Recall Bulletin

F/CMVSS NONCOMPLIANCE RECALL

SUBJECT: Passenger Side Instrument Panel Performance

MODELS: 2009-2014 Chevrolet Express
2009-2014 GMC Savana
2500/3500 Series Equipped with Front Passenger Side Airbag (AK5) and
GVWR of 10,000 Pounds (4536 kg) and Below

3785217

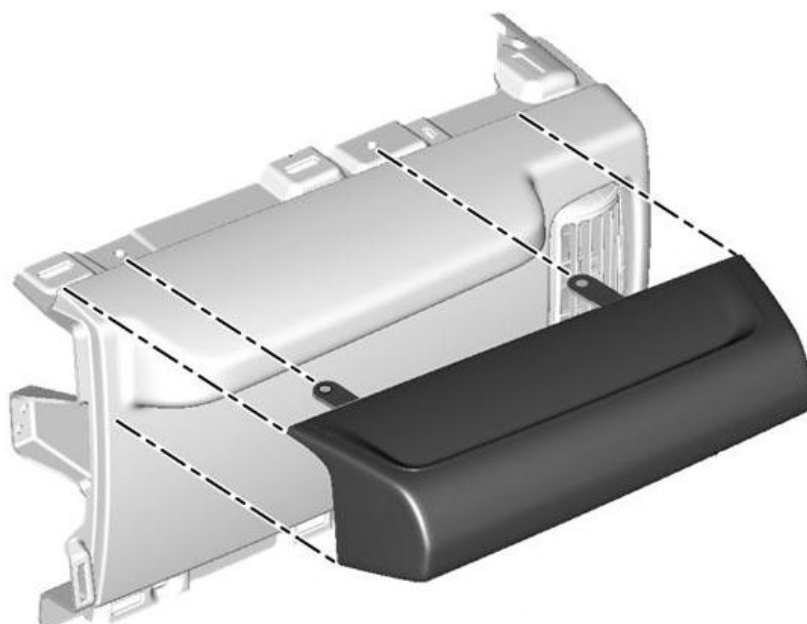
General Motors has decided that certain 2009-2014 model year Chevrolet Express and GMC Savana vehicles with a GVWR of 10,000 pounds (4536 kg) and below equipped with front passenger air bags fail to conform to Federal/Canada Motor Vehicle Safety Standard 201, *Occupant Protection in Interior Impact*. On these vehicles, during a frontal impact below the air bag deployment threshold, if an unrestrained front passenger head hits the instrument panel above where the passenger airbag is located, it may decelerate at a rate exceeding the requirements of FMVSS 201, resulting in a greater risk of injury.

Dealers are to install a trim piece on the passenger side instrument panel.

1. Remove the instrument panel upper trim pad. *Refer to Instrument Panel Upper Trim Pad Replacement in SI.*

2. Remove the upper two screws that attach the instrument panel pad to the instrument panel bracket.
